**METROPOLITAN GOVERNMENT OF NASHVILLE AND DAVIDSON COUNTY**

**STAFF RECOMMENDATION**  
**1820 Fifth Avenue North**  
**March 19, 2014**

**Application:** New construction-infill  
**District:** Salemtown Neighborhood Conservation Zoning Overlay  
**Council District:** 19  
**Map and Parcel Number:** 08108027200  
**Applicant:** Robin York; R. J. York Homes, LLC  
**Project Lead:** Sean Alexander, sean.alexander@nashville.gov

Alley

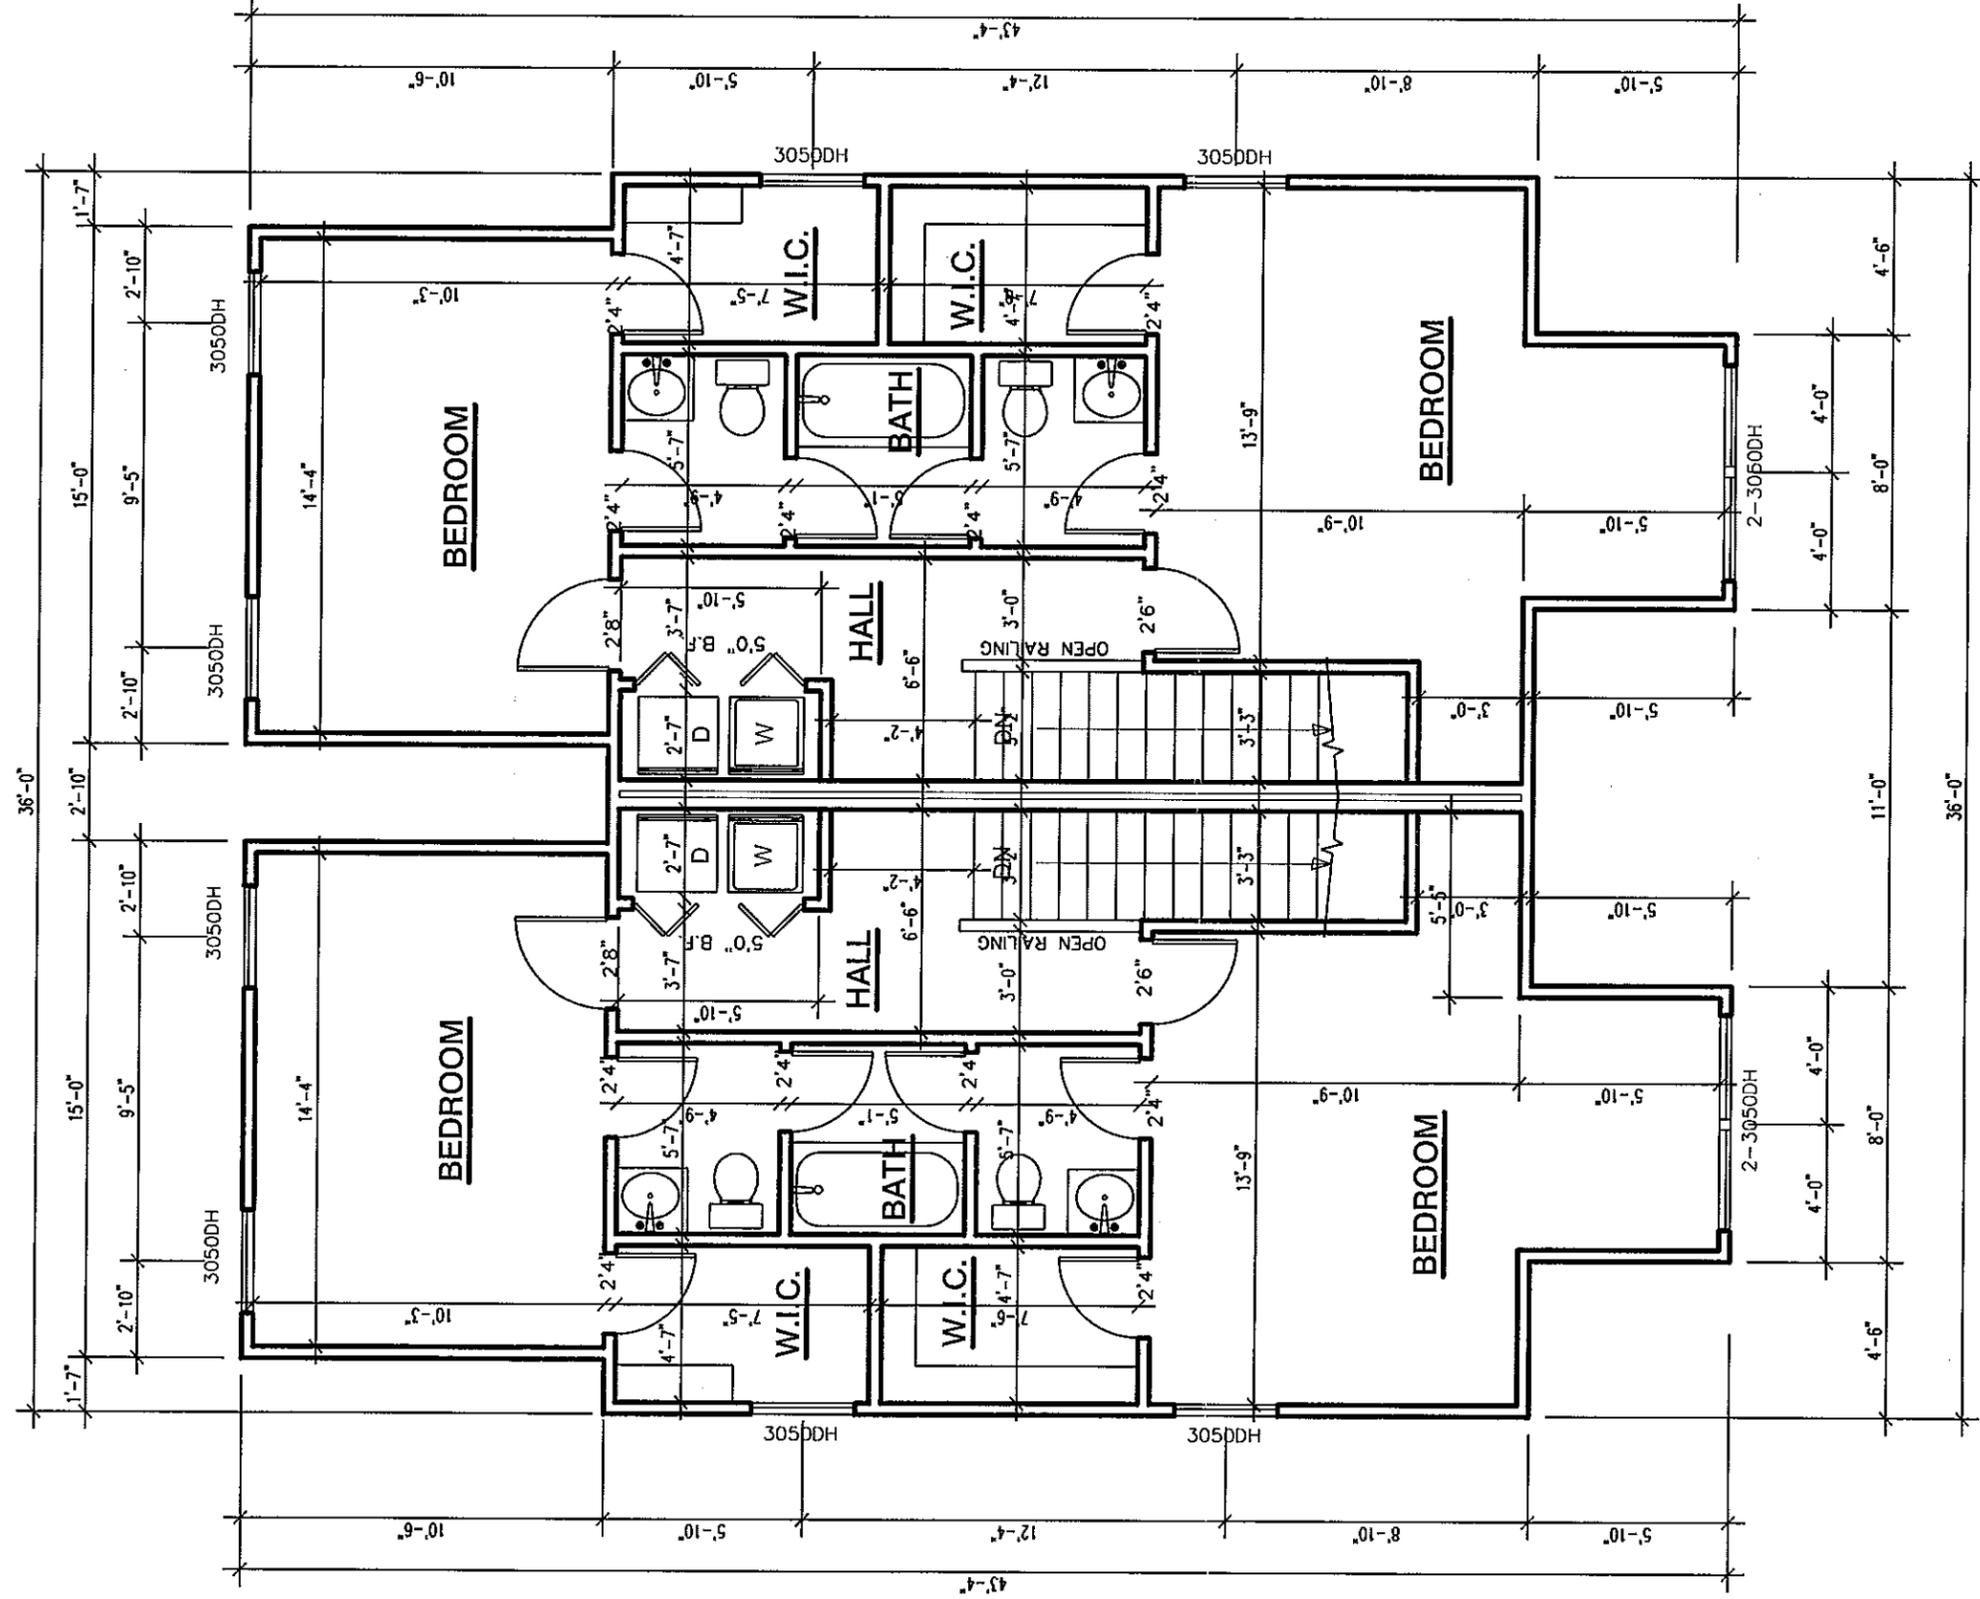
The proposed infill will be centered on the lot and will meet all base zoning setback requirements. The structure will be six feet (6') from each of the side property lines, creating similar spacing between it and adjacent structures as is found in the historic context and maintaining the established rhythm of the street.

The front porch on the right side will be twenty-six feet (26') from the front property line. This setback is in between the two nearest historic structures, the setbacks of which are twenty-one feet (21') and thirty-two feet (32'). Staff finds that the duplex's setbacks are compatible with the historic context and will maintain the established rhythm of the street, and that the proposal will meet Section III.C of the *Salemtown Neighborhood Conservation Zoning Overlay: Handbook & Design Guidelines*.

The site plan shows a detached garage at the rear of the lot, but no other plans for it have been submitted for review at this time.

**FRONT ELEVATION**  
 SCALE: 1/4"=1'-0"

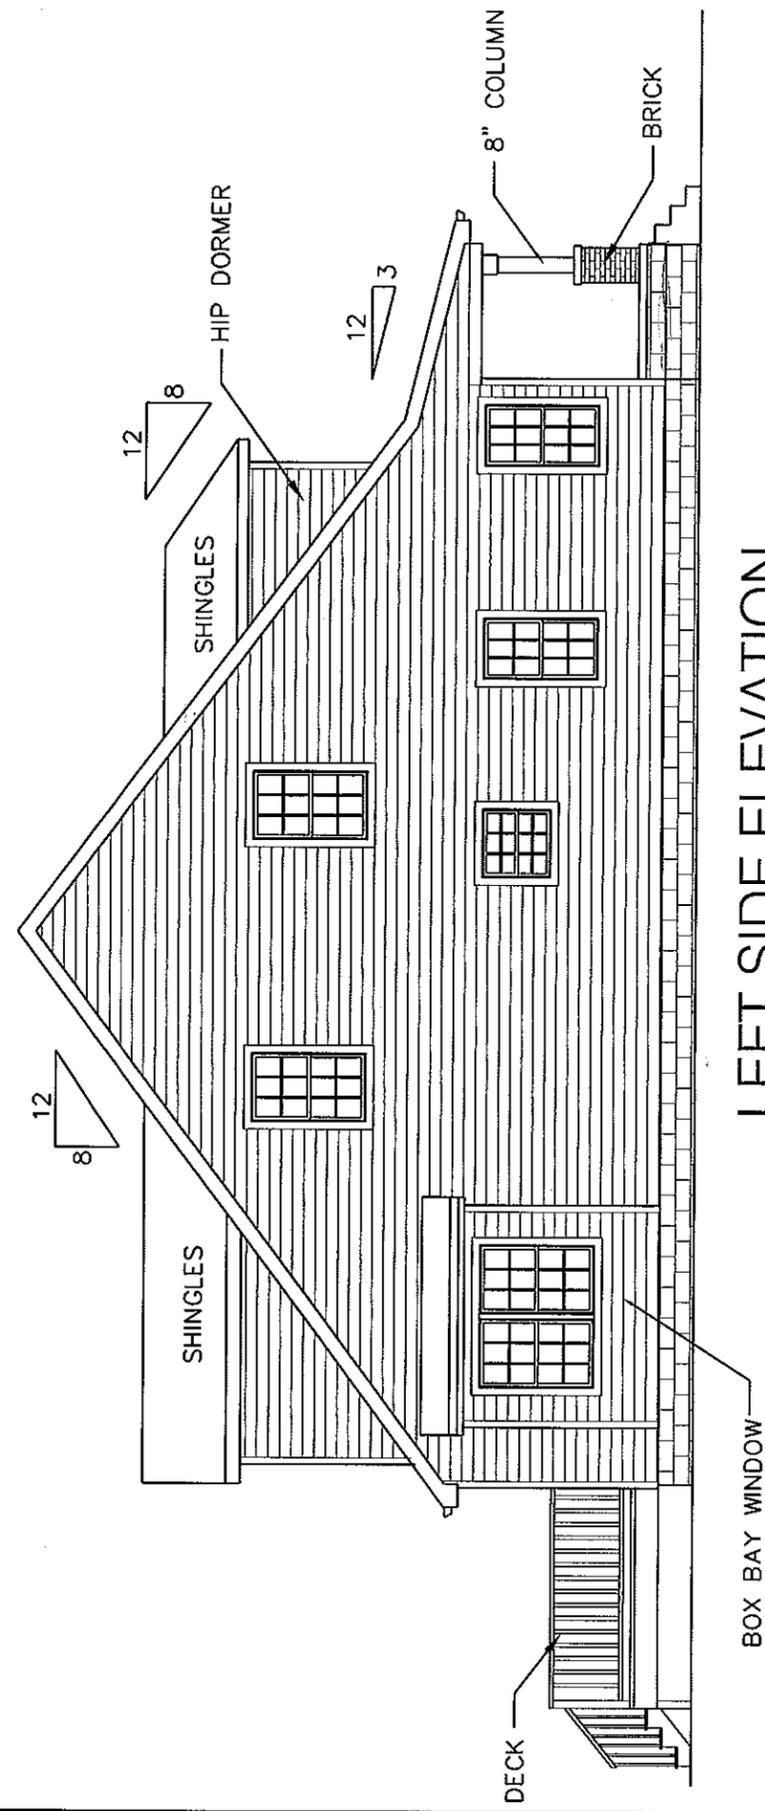
The building will have one foot, six inches (1'-6") of exposed foundation on the primary walls, with the foundation on the front wall twelve inches (12") taller. Staff recommends, as a condition of approval, that the thickness of the porch floor be increased so as to lower the foundation height at the front and that a water-table band be added at the floor level.

The house's primary roof form will be a side-oriented gable with a pitch of 8:12 and a pair of hipped-roof dormers on the front. The dormer roofs will also have an 8:12 pitch. The porch roof will be a shed with a 3:12 pitch. These roof forms are common in the surrounding historic context, and Staff finds that the duplex's roof forms meet Section III.E of the *Salemtown Neighborhood Conservation Zoning Overlay: Handbook & Design Guidelines*.

The infill will face Fifth Avenue North and will match the orientation of historic structures on the street. The two-family dwelling will have two front-entry doorways, one to each unit. The proposal does not indicate the creation of a front walkway, which is a standard feature in the historic district. Staff recommends adding a walkway to address the street in the manner typical of historic houses nearby. With the addition of a walkway, Staff finds that the project meets guideline Staff finds that the duplex's orientation meets Section III.F. of the *Salemtown Neighborhood Conservation Zoning Overlay: Handbook & Design Guidelines*.

- That the roof and eaves of the front porch be raised to make the perceived height of the first story taller, in relation to the upperstory;
- That the thickness of the porch floor and porch rack be increased to a size more compatible with nearby historic houses;
- That a water-table is added at the floor level;
- Staff review and approve the roof color and the materials for the trim, as well as the porch columns, porch floor, and foundation;
- Staff review and approve all window and door selections prior to purchase and installation; and,
- The HVAC unit be placed at the rear, or on a side façade beyond the midpoint of the house.
